SERVICE CAMPAIGN BULLETIN

CAMPAIGN REF: 02B
TITLE : HVAC Drain tube valve replacement
DOCUMENT # : 12 A 004
AFFECTED VEHICLES : McLaren P1™

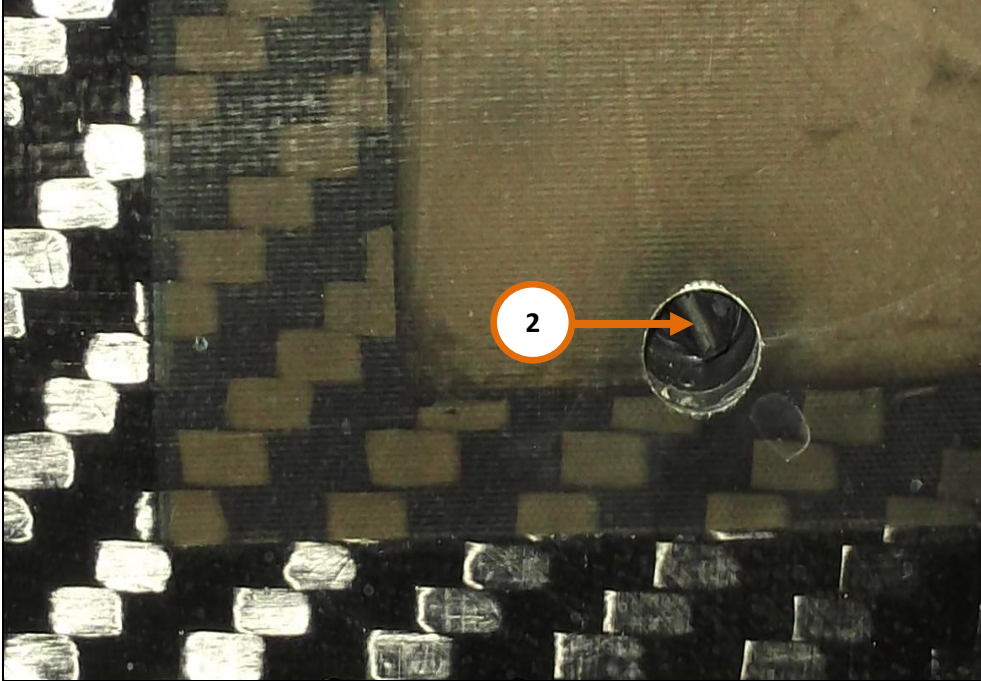
SITUATION : Quality Engineering at McLaren Automotive have identified a potential risk of water leaking inside the cabin into the driver and passenger footwell areas.

1. Lift the vehicle on platform. Please refer to BA-RM-01A001-00-001 – Secure/Lift vehicle on platform.
2. Locate the HVAC drain tube valve in the front floor panel (1).

3. Remove the valve (2) from the drain tube using a pair of long nose pliers.

4. Install the new drain valve 11A7034CP into the drain tube, ensuring that it is correctly located (3).
